Access Compliance Report Public Rights-of-Way (Curb Ramps)

Main Street: LEAFWOOD_LN Cross Street: CARLSBAD_DR Location: NW

ADA ID: RPAT211019110845 Ramp Type: Type 1 - Perpendicular Diagonal Initial Pass/Fail: Fail Overall Compliance: No Severity Score: 4

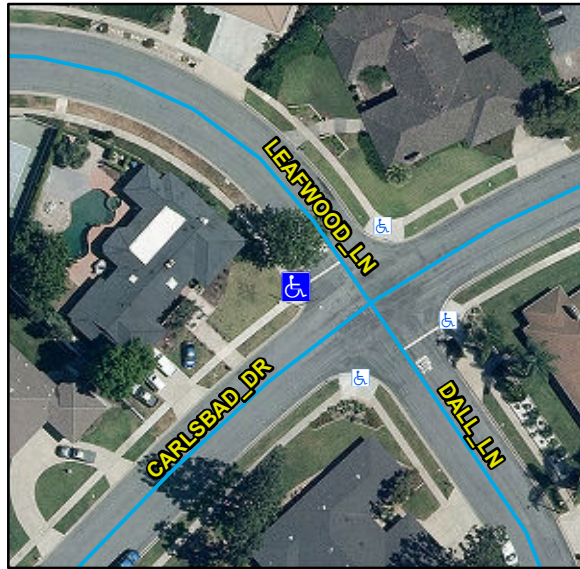
Compliance	Description	Data	Compliance	Description	Data
N/A	Ramp Length (in)	93	N/A	Flare Type LT	
No	Ramp Width (in)	43			N/A
Yes	Ramp Run Slope (%)	7.7	N/A	Flare Slope LT (%)	N/A
Yes	Ramp Cross Slope (%)	0.5	N/A	Flare Traversable LT	N/A
N/A	Landing Present	N/A	N/A	Flare Type RT	
N/A	Landing Length (in)	N/A			N/A
N/A	Landing Width (in)	N/A	N/A	Flare Slope RT (%)	N/A
N/A	Landing Run Slope (%)	N/A	N/A	Flare Traversable RT	N/A
N/A	Landing Cross Slope (%)	N/A	N/A	DWS Provided	N/A
N/A	Landing Movement Obstructed?	N/A	N/A	DWS Contrast	N/A
	Landing Movement Type	N/A	N/A	DWS Length (in)	N/A
N/A	Landing Shared	N/A	N/A	DWS Full Width	N/A
N/A	Clear Space	Yes	N/A	DWS Offset Left (in)	N/A
N/A	Clear Space To Crosswalk (in)	N/A	N/A	DWS Offset Right (in)	N/A
N/A	Marked Crosswalk 1	No	N/A	Marked Crosswalk 2	No
	Crossing 1 Direction	S		Crossing 2 Direction	E
	Marked Crosswalk 1 Width (in)	N/A		Marked Crosswalk 2 Width (in)	N/A

N/A	Ramp Inside Crosswalk 1	N/A	Yes	Ramp Inside Crosswalk 2	N/A
	Crossing 1 Slope (%)	2.1		Crossing 2 Slope (%)	3.3
	Crossing 1 Cross Slope (%)	1.6		Crossing 2 Cross Slope (%)	0.3
N/A	Gutter Ponding	N/A	No	Curb Slope	6.5
Yes	Gutter Lip Height (in)	0		Road Run Slope (%)	0.1
N/A	Gutter Run Slope (%)	N/A		Road Cross Slope (%)	4.9
N/A	Gutter Cross Slope (%)	N/A			
Yes	Overall Surface Condition: Acceptable		Yes	Perp Joint Present	Yes
	Cross Gutter Present?	No		Spandrel Present?	No
	Replace Cross Gutter?	Yes		Replace Spandrel?	Yes

Remove & Replace Curb Ramp With Two New Directional Ramps or Equivalent.
